**SOLICITATION AMENDMENT
MODIFICATION DE L'INVITATION**

Title - Sujet IOS Guardhouse	
Solicitation No. - N° de l'invitation F1700-204430/A	Amendment No. - N° modif. 004
Client Reference No. - N° de référence du client F1700-204430	Date 2020-07-23
GETS Reference No. - N° de référence de SEAG PW-SPWY-041-8790	
File No. - N° de dossier PWY-0-43025 (041)	CCC No./N° CCC - FMS No./N° VME
Solicitation Closes - L'invitation prend fin at - à 02:00 PM on - le 2020-07-31	
Time Zone Fuseau horaire Pacific Daylight Saving Time PDT	
F.O.B. - F.A.B. Plant-Usine: <input type="checkbox"/> Destination: <input checked="" type="checkbox"/> Other-Autre: <input type="checkbox"/>	
Address Enquiries to: - Adresser toutes questions à: Sezginalp (PWY), Kipp	Buyer Id - Id de l'acheteur pwy041
Telephone No. - N° de téléphone (604) 367-5341 ()	FAX No. - N° de FAX (604) 775-6633
Destination - of Goods, Services, and Construction: Destination - des biens, services et construction: DFO - Institute of Ocean Science - Sidney, BC

Solicitation Amendment 004 is raised to issue Addendum 003 and Addendum 004.

FISHERIES AND OCEANS CANADA
INSTITUTE OF OCEAN SCIENCES
NEW GUARDHOUSE
9860 WEST SAANICH ROAD
SIDNEY, BC, V8L

SCALE AS NOTED
START DATE
DRAWING NUMBER **E110**
5 OF 11
REVISION 2

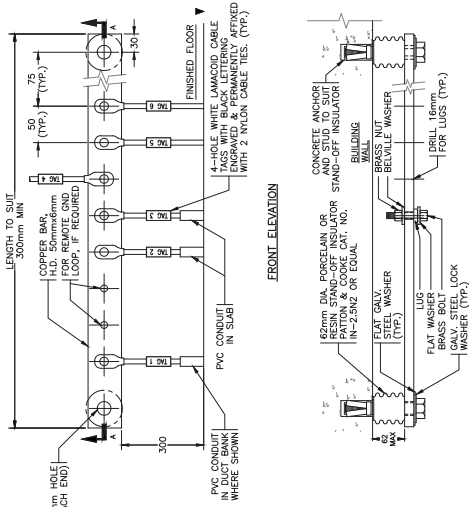
- 1.1 Drawing E110: Delete Electrical Drawing E110, Rev. 1. Replace with Electrical Drawing E110, Rev. 2.
 - 1.1.1 Accessible washroom door controls added.
 - 1.1.2 Extent of surface raceway at desk modified.
 - 1.1.3 Keynotes modified.
- 1.2 Drawing E111:
 - 1.2.1 Delete Keynote 3 "Install data cabling and leave coiled in cable tray with 3m of slack, for future connection to patch panel in security data rack"
 - 1.2.2 Insert Keynote 3: "All data cabling installed in tray shall be coiled above data rack location with a minimum of 3m of slack, for connection in rack by others. This contractor shall terminate and test all data cabling installed as part of this contract."
- 1.3 Drawing E515: Delete Electrical Drawing E515, Rev. 0. Replace with Electrical Drawing E515, Rev. 1.
 - 1.3.1 Accessible washroom door control detail added.

- 3.1 Q: Page E110 note 16 states all data lines are to be SSC unless noted otherwise. And that they are to be installed by other (rough in only). Is the electrical Contractor to supply anything other than rough in for this project? Racks equipment cables terminations or just conduit, cable tray, and blank covers? I will supply rough in only as per note 16 on E110. Please clarify if otherwise.

- 3.2 Q: Page E110 Note 3 – What do we need to allow for this

3.3 Q: Security room 107 indicates two ceiling mounted receptacles, but two floor mounted data in the same location, please confirm if this is correct & if not what is required in these locations.

3.4 Q: Note 15 – Does not appear on the drawing, please confirm location if needed.

A: Provide rough-in only as indicated. Where identified by keynote 19, also provide cables, terminations, and data outlets as required. All other data work shall be completed by Shared Services Canada. Provide data rack, horizontal PDU, UPS and electrical bonding only as indicated in drawings.

A: This note is for information only. All work associated with these two access controllers is by others.

A: All symbols shown on the drawing are for ceiling mount receptacles and data. No floor mount symbols are shown.

A: Note 15 is shown on Area Enlargement 1 of drawing E110.
